ADDENDUM NO. 1

RE: Indiana University Bloomington
BL000B Multi-Building – BL057 Wylie and BL065 Optometry
Classroom Renovations

PROJECT No.: 20250503

DATE: March 20, 2026

D102

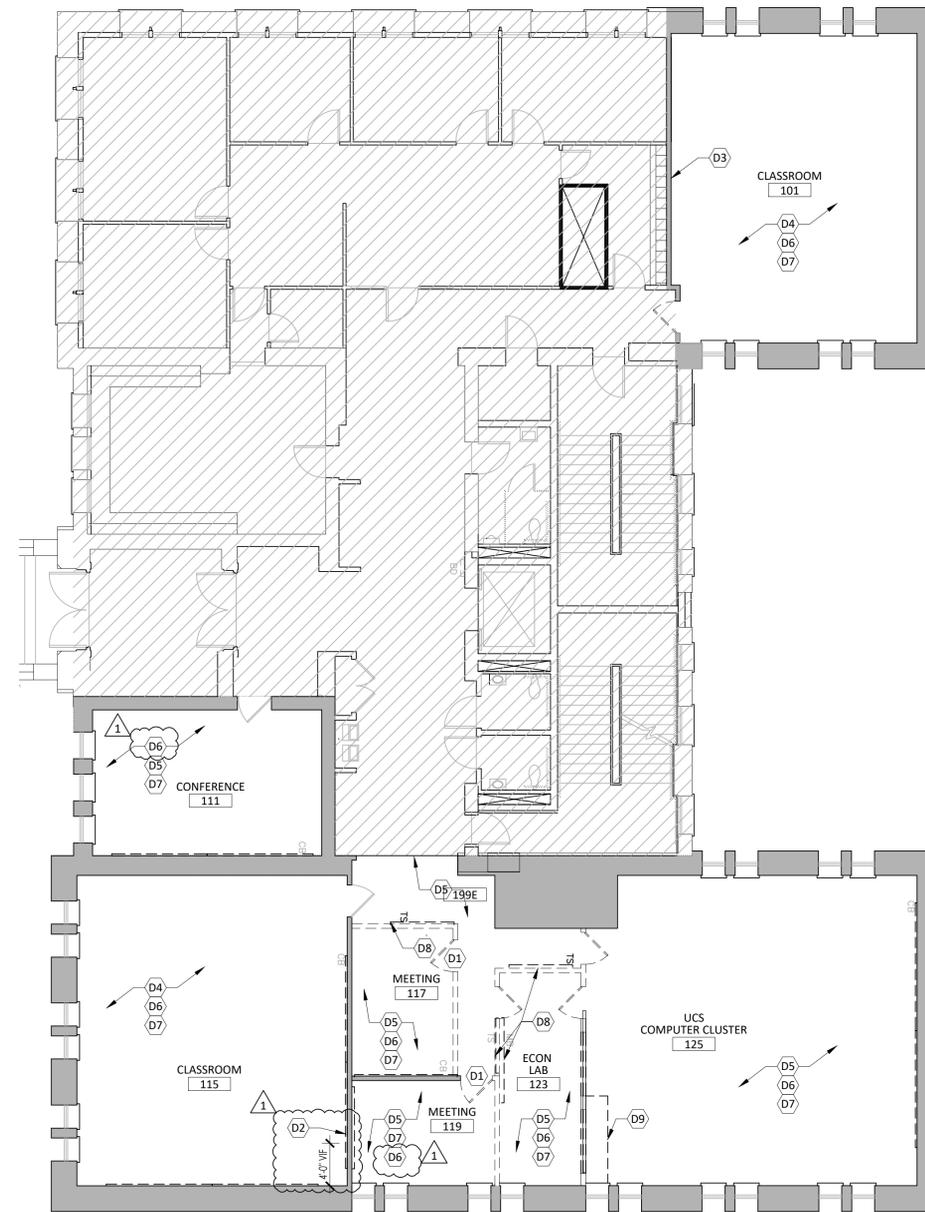
1. Sheet D102 – BL075 WYLIE HALL FIRST FLOOR DEMOLITION PLAN, see attached.
 - a. DEMOLITION PLAN NOTES
 - i. Revise D2 to read: “REMOVE 32” STRIP OF EXISTING GYP. WALL BOARD FROM FLOOR TO CEILING FOR NEW FSR BOX & CONDUIT, REF E-SERIES”

- b. A/D102 DEMO FLOOR PLAN
 - i. Replace Demolition Plan Note D4 with D6 at Conference 111, see attached.
 - ii. Add Demolition Plan Note D2 at Classroom 115, see attached.

- iii. Add Demolition Plan Note D6 at Meeting 119, see attached.
 - c. B/D102 DEMO RCP (change drawing title designation, see attached)
 - i. Remove miscellaneous notes at Conference 111, see attached.

A102

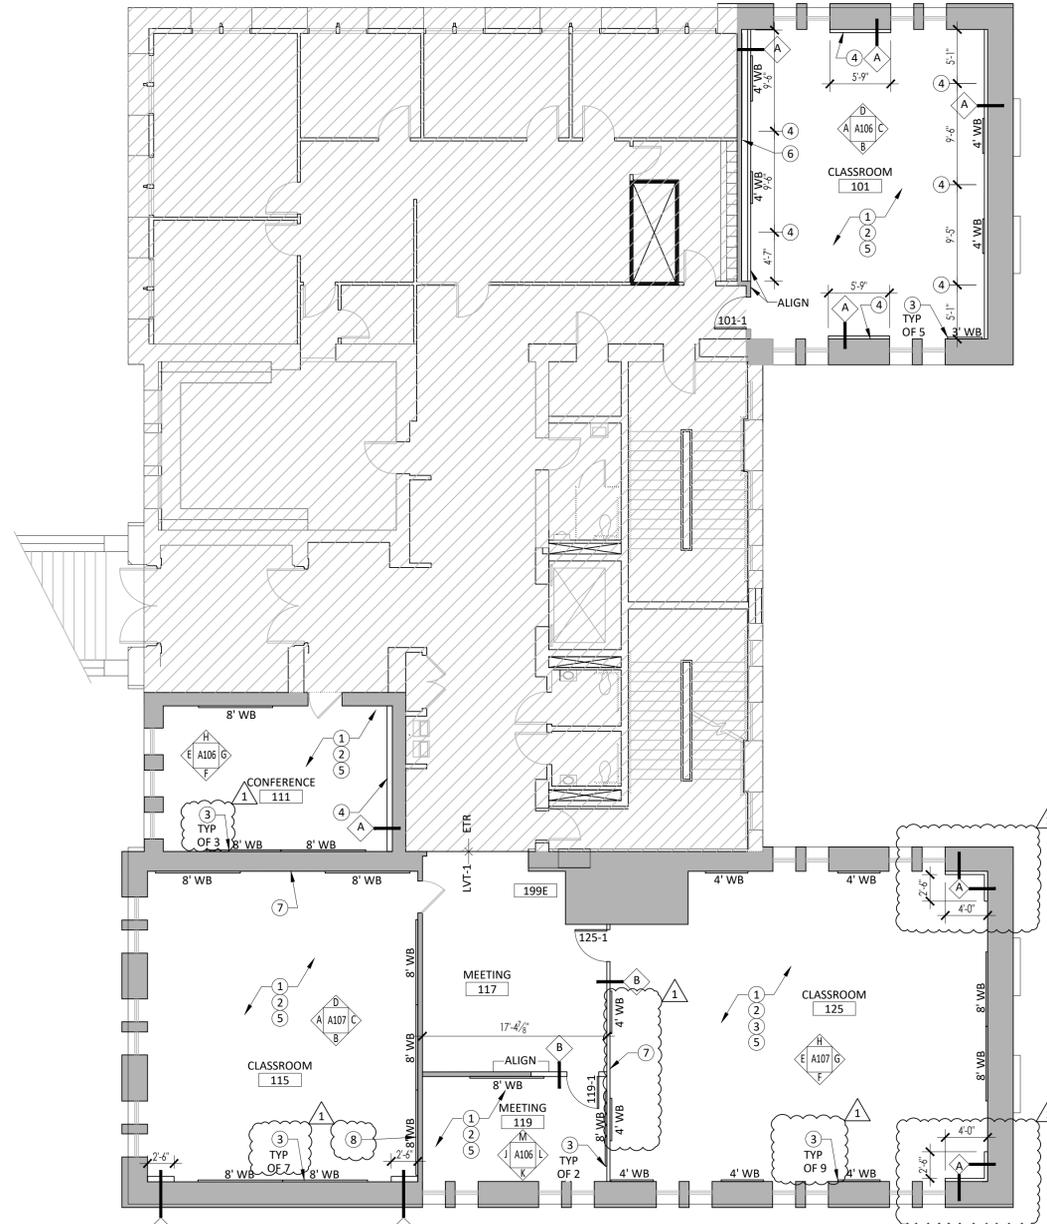
- iii. At Hall 005A and Hall 015C, windows to receive motorized shades (Alternate Bid) are 2’-3”W x 5’-4”H.
3. Sheet A102 – BL057 WYLIE HALL FIRST FLOOR PLAN AND SCHEDULES, see attached.

- a. PLAN NOTES
 - i. Add Plan Note 8 as follows “PATCH EXISTING WALL AT NEW FSR BOX AND CONDUIT LOCATIONS, REFERENECE E-SERIES”
 - b. A/A102 FLOOR PLAN

- i. Revise Plan Note 3 quantities at Conference 111, Classroom 115, and Classroom 125, see attached.
 - ii. Add Plan Note 8 at southeast corner of Classroom 115, see attached.

- iii. Revise white boards at west wall of Classroom 125, see attached.
 - iv. Add additional framing at northeast and southeast corners of Classroom 125, see attached.

- v. Add additional wall type indicators at Classroom 101.
 - c. ROOM FINISH SCHEDULE
 - i. Change Floor at Conference 111 and Meeting 119 from LVT-1 to CPT-1, see attached.

H100

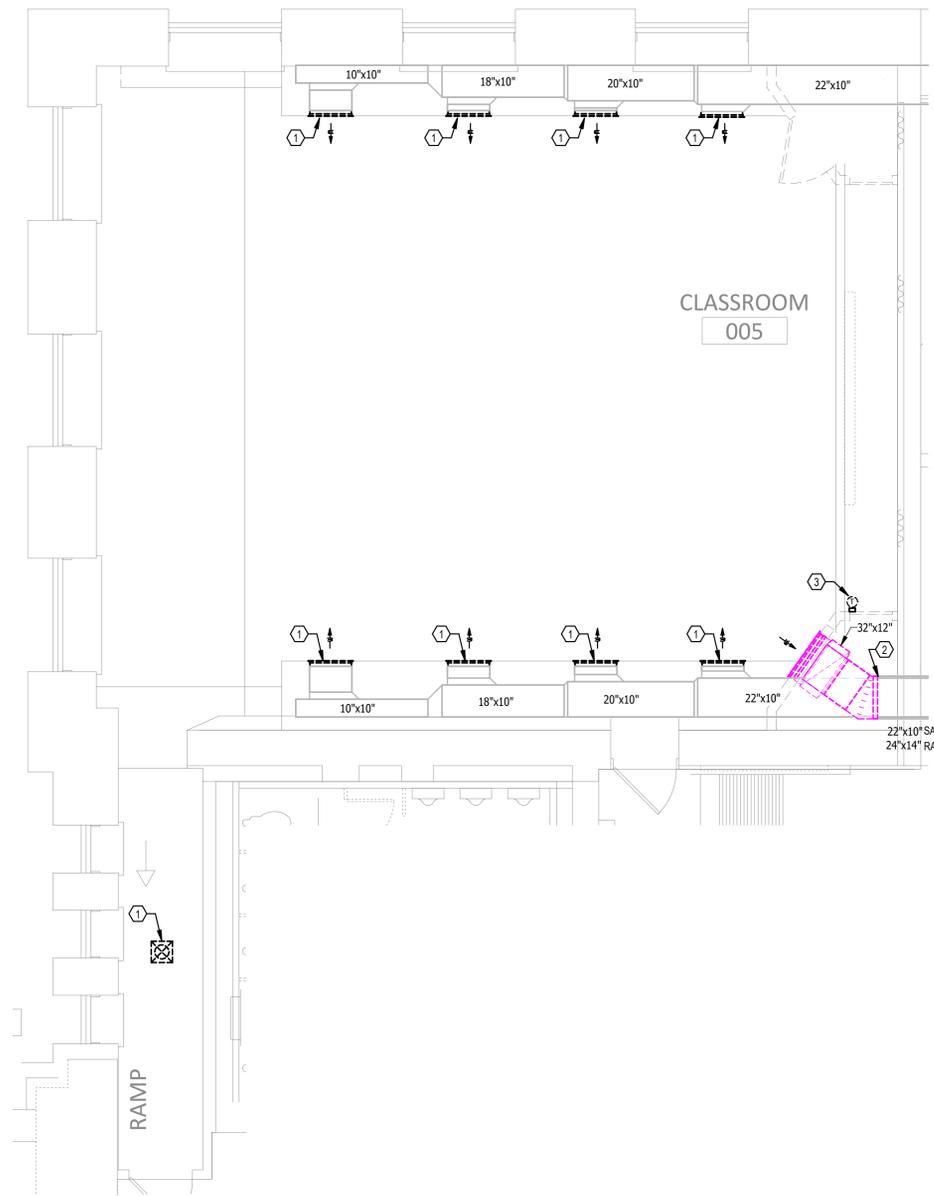
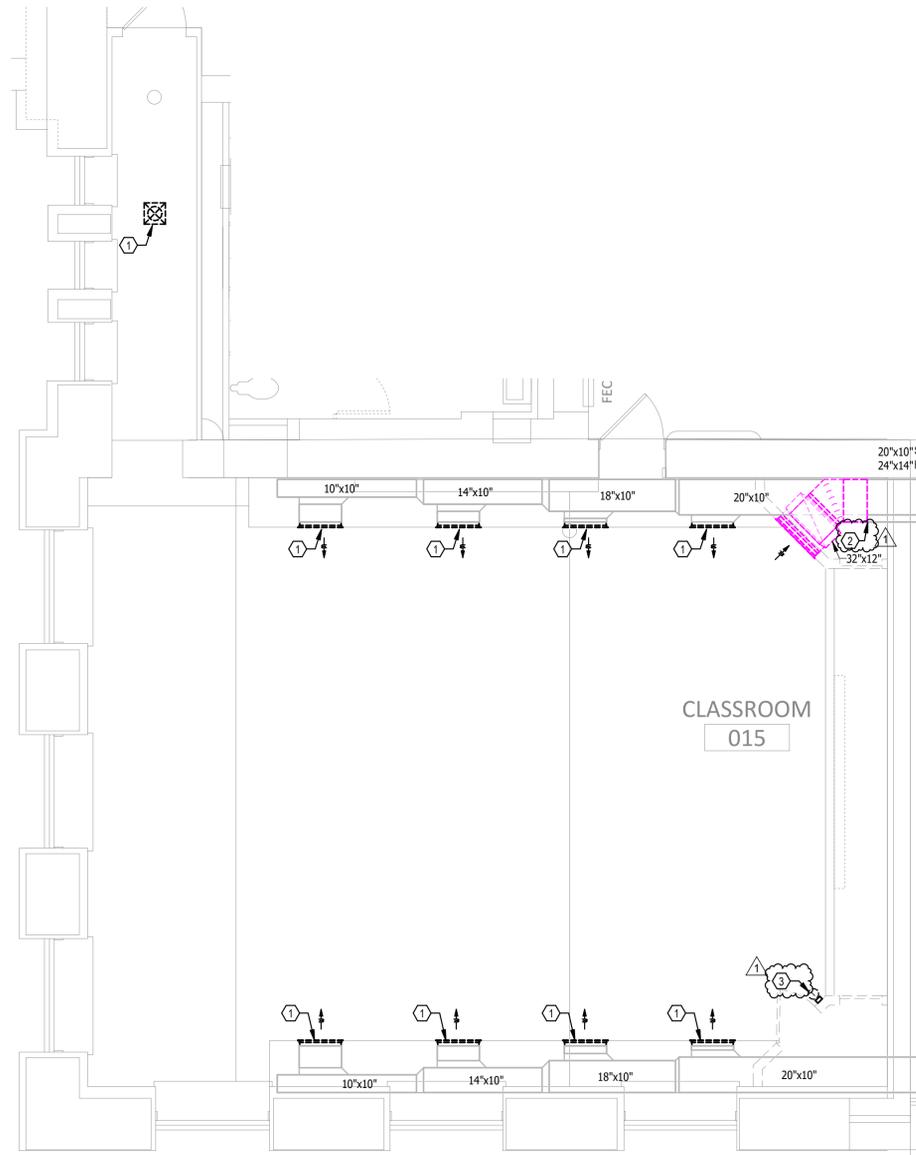
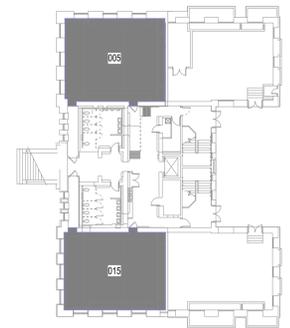
7. Sheet H100 – BL057 WYLIE HALL GROUND FLOOR HVAC DEMOLITION PLANS
 - a. Switched plan note 2 and 3 within classroom 015.
 - b. Revised plan notes.
8. Sheet H101 – BL057 WYLIE HALL FIRST FLOOR HVAC DEMOLITION PLANS

H101

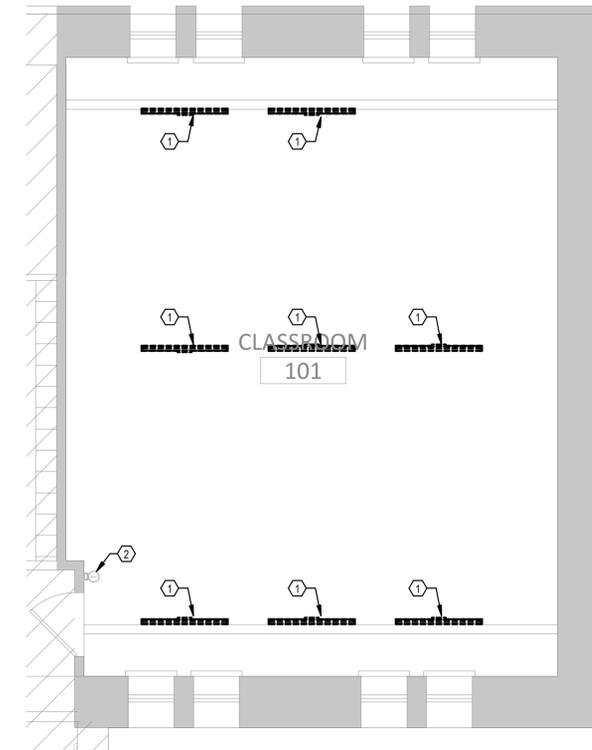
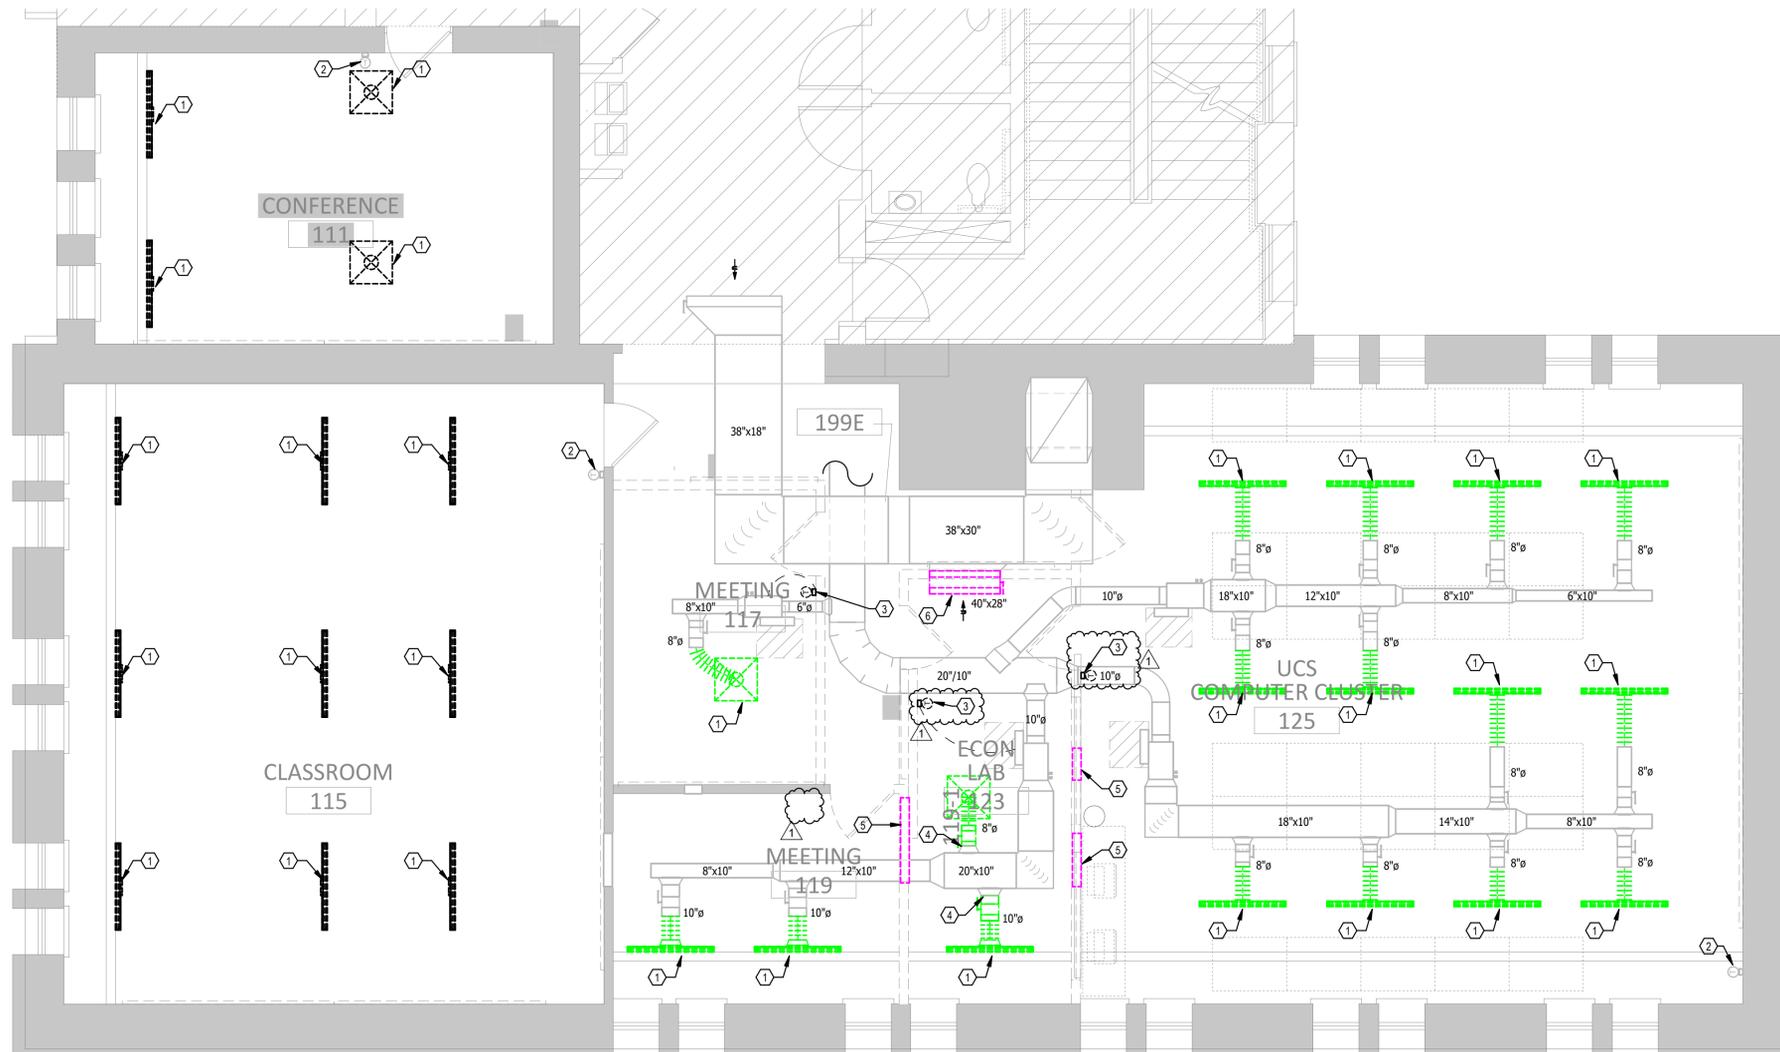
- a. Revised plan notes.
 - b. Added existing thermostat within “USC COMPUTER CLUSER 125”
 - c. Relocated thermostat from “MEETING 119” to “ECON LAB 123”.

H200

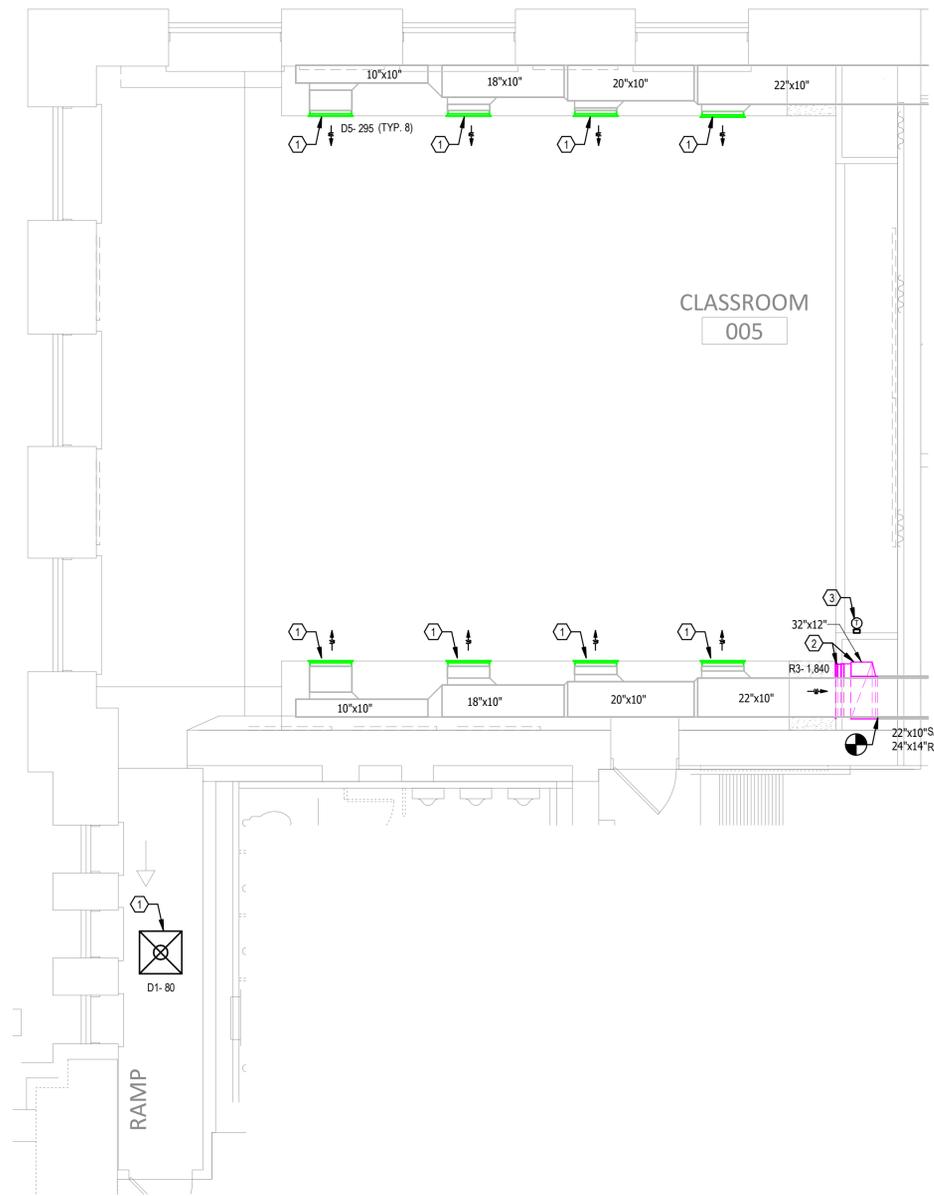
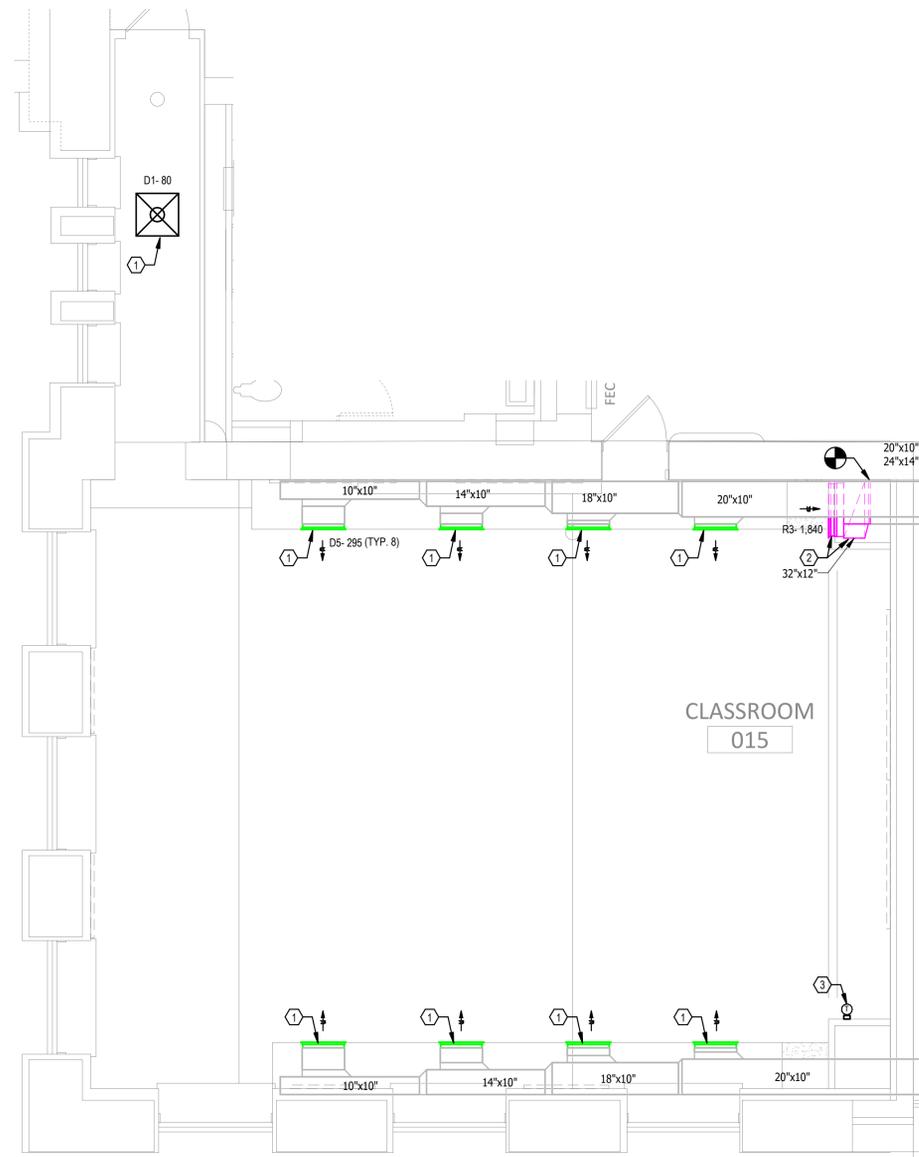
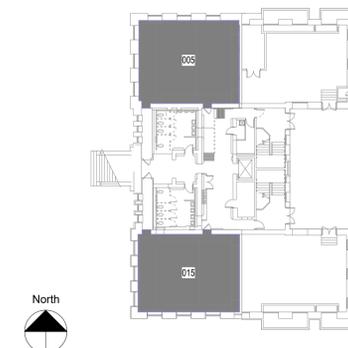
9. Sheet H200 – BL057 WYLIE HALL GROUND FLOOR HVAC PLANS
 - a. Revised plan notes.
10. H201- BL057 WYLIE HALL FIRST FLOOR HVAC PLANS
 - a. Revised plan notes.
